PROJECT NUMBER: SP2022-050
PROJECT NAME: Site Plan for Bacon Plumbing Phase 2
SITE ADDRESS/LOCATIONS: 2055 KRISTY LN

CASE CAPTION: Discuss and consider a request by Jeff Carroll of Jeff Carroll Architects on behalf of Brad Bacon of Bacon Property, LLC for the approval of an Amended Site Plan for an existing Office/Warehouse facility on a 0.50-acre parcel of land identified as Lot 1, Block A, Bacon Addition, City of Rockwall, Rockwall County, Texas, zoned Light Industrial (LI) District, situated within the IH-30 Overlay (IH-30 OV) District, addressed as 2055 Kristy Lane, and take any action necessary.

TO: Planning and Zoning Commission
DATE: October 11, 2022
APPLICANT: Jeff Carroll; *Jeff Carroll Architects*
CASE NUMBER: SP2022-050; *Amended Site Plan for Bacon Plumbing*

SITE PLAN

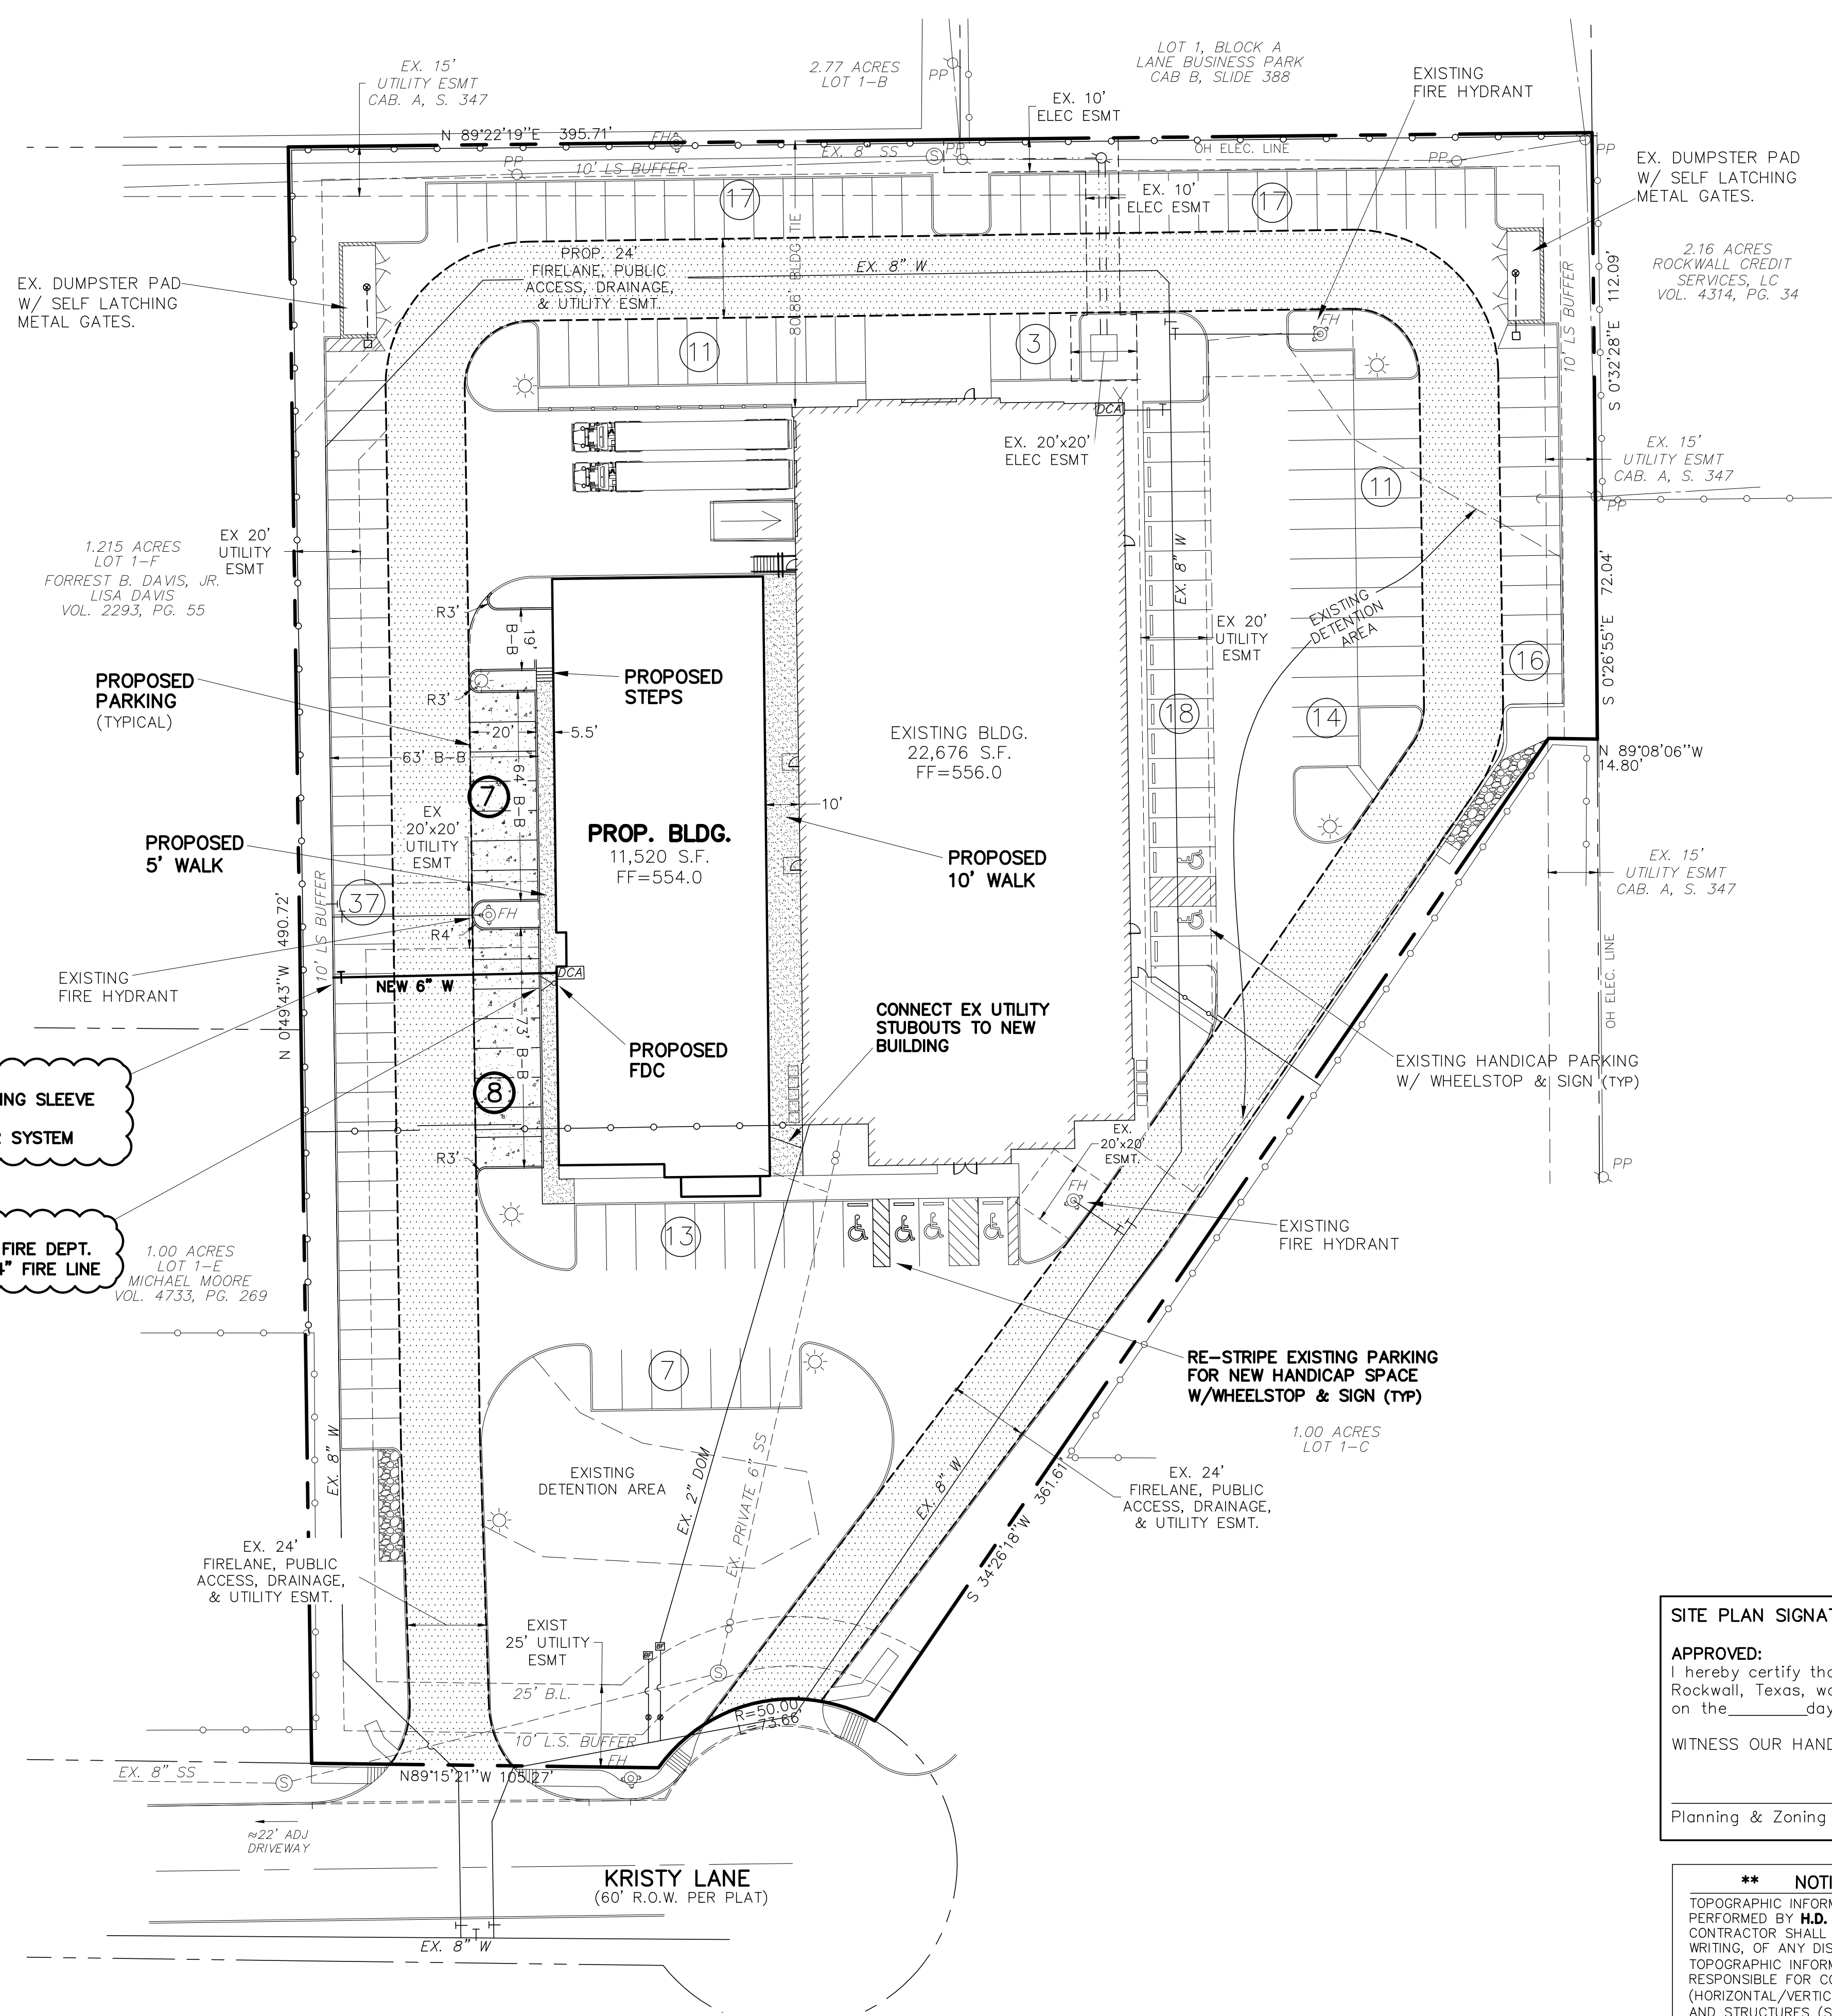
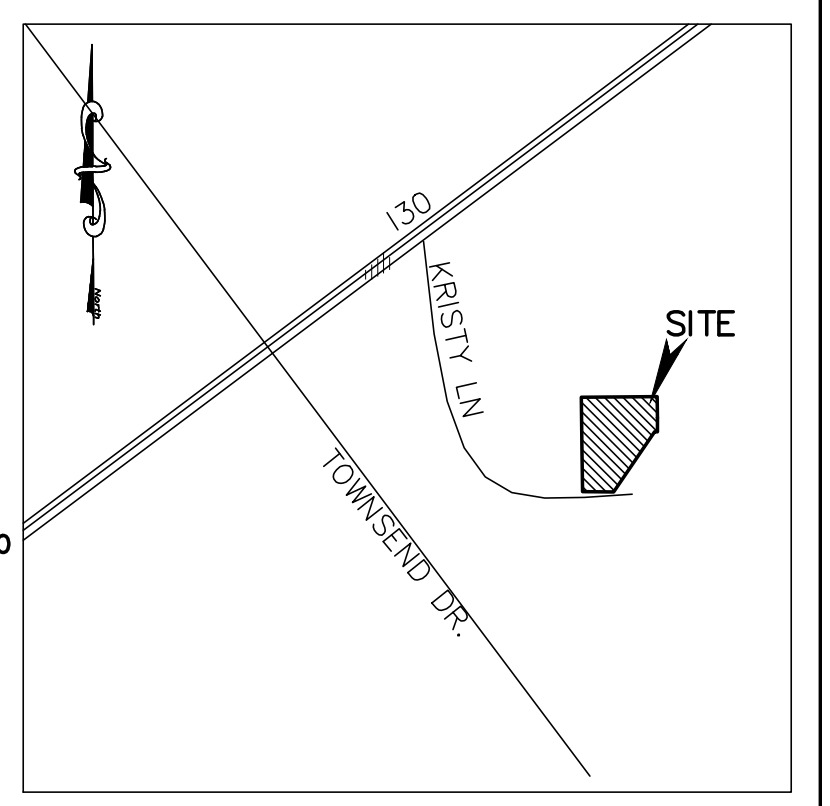
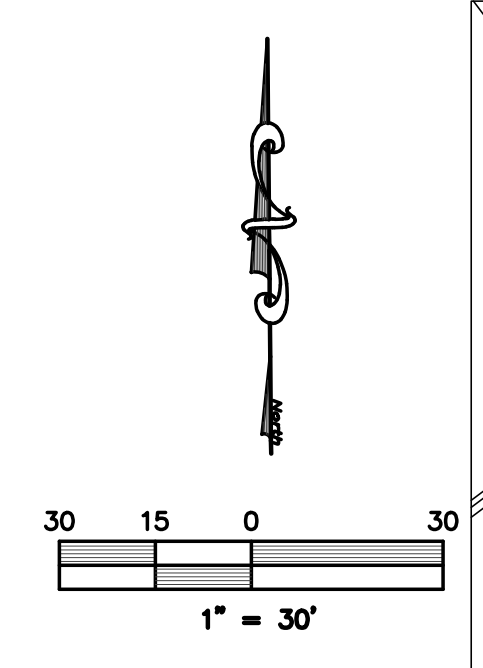
M.6 Site Plan:

1. The distance between buildings must be 15-feet, otherwise a fire rated wall is required. (Subsection 03.04. B, of Article 11)
2. Provide the perimeter dimensions of the proposed building. (Subsection 03.04. B, of Article 11)

3. Please provide the dimension for a typical parking space. (Subsection 05.03, of Article 06)
4. Please confirm the required parking indicated within the site data. Per the table only the existing building is calculated for. (Subsection 05.01, of Article 06)

9. The proposed off-street loading must be screened. Provide landscape screening on the west property line. (Subsection 01.05. A, of Article 05)

09/21/2022: Will need to revise detention pond B so that the building is located outside of the easement. (see last page)

- Replat is required to revise easements.
- All paving will be concrete.
- Longitudinal Butt joint needed to tie in concrete to existing.
- Will there be a new water meter?
- Parking island for the fire hydrant must be 10' wide minimum.

EXTERIOR ELEVATIONS
DATE: _____ SHEET NO.: _____
PROJECT NO: AUG 2022
DRAWN BY: 2020021 **A501**
CHECKED BY: _____

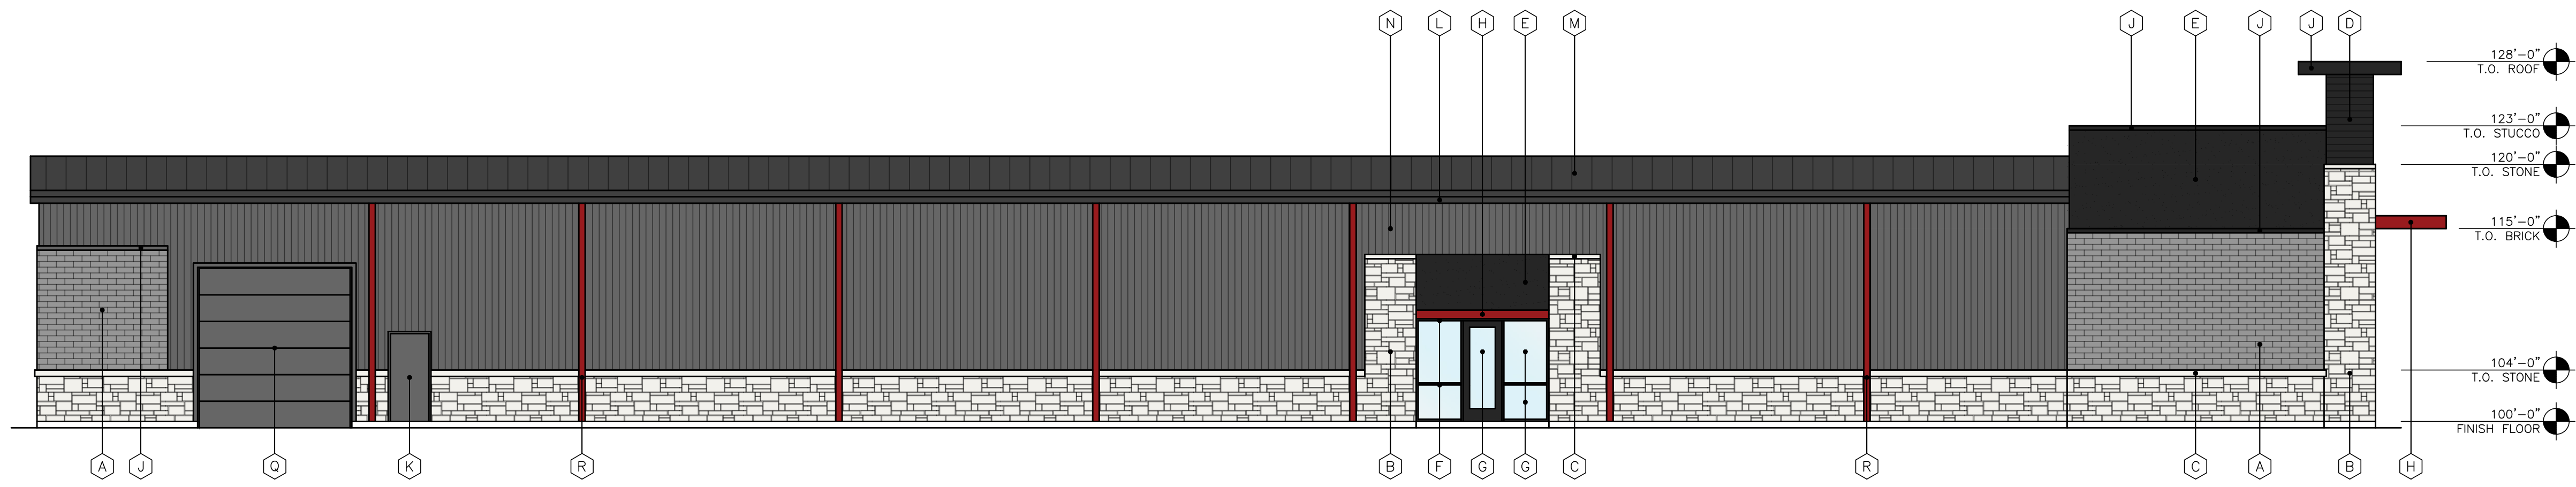
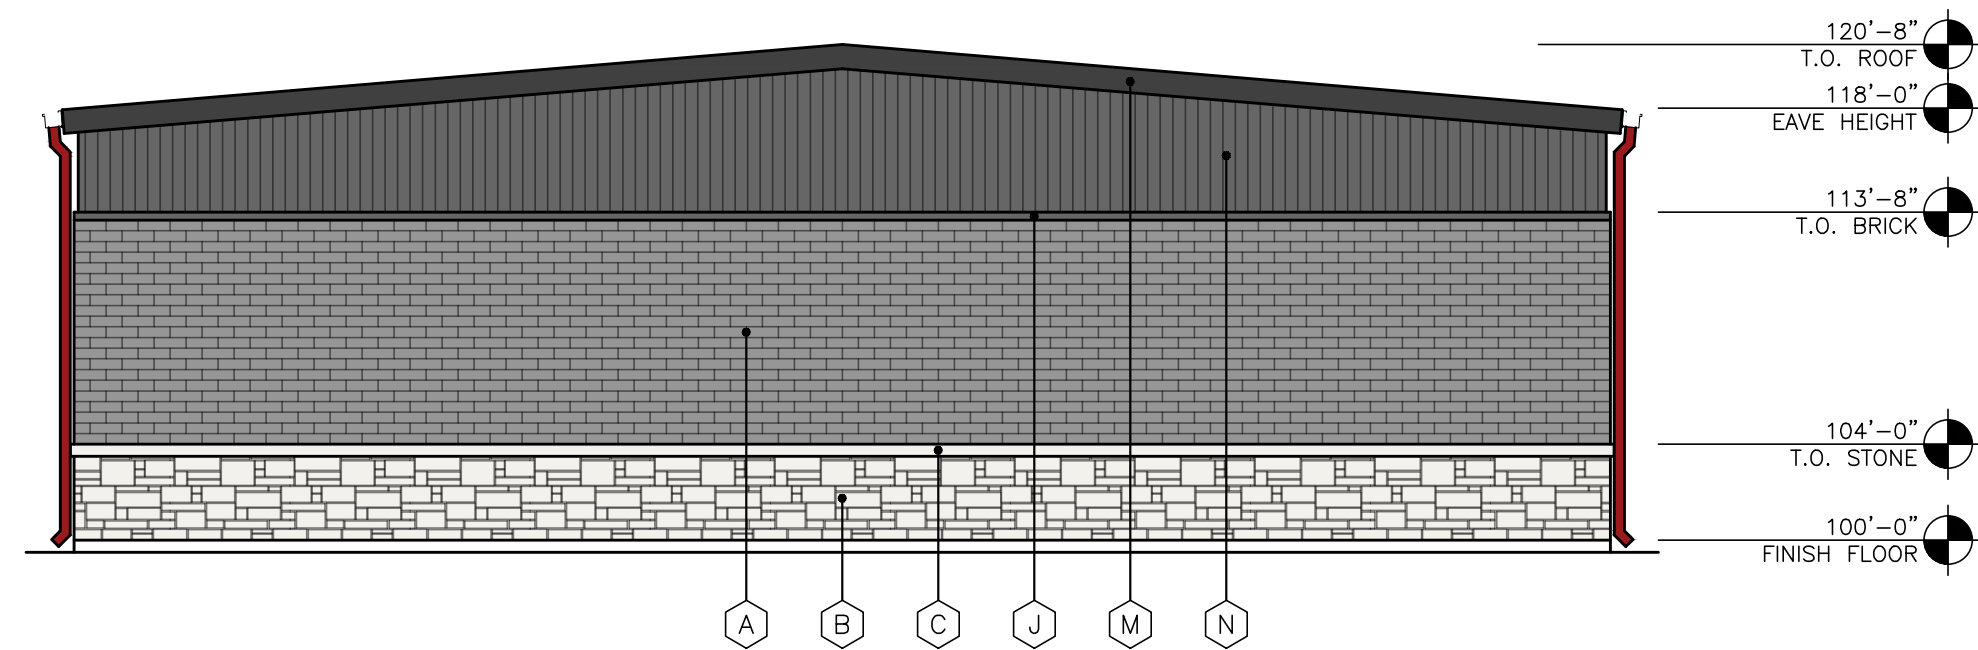
1. Please provide the material percentages for each side of the building. (Subsection 05.01. A. 1, of Article 05)
2. Please indicate the cardinal directions of the building facades. (Subsection 05.01, of Article 05)

3. Please show the ghost the parapets that are in the background of a building façade. (Subsection 05.01, of Article 05)
4. Please add depth to the parapet on the "Front" elevation. (Subsection 05.01, of Article 05)

5. Please provide a note indicating that the parapet will be finished on both sides with the same material as the exterior facing wall. (Subsection 05.01, of Article 05)

I.8 Staff has identified the following variances associated with the proposed request: [1] greater than 50% cementitious material, [2] less than 20% stone, and [3] four-sided architecture. Should you decide to request these items as variances, please provide a letter that lists the variances, why they are being requested, and the subsequent compensatory measures. For each variance requested you must provide two (2) compensatory measures (Subsection 09.01, of Article 11). Examples of compensatory measures include the increased use of masonry material or stone, increased articulation, increased architectural elements, more pedestrian amenity, etc.
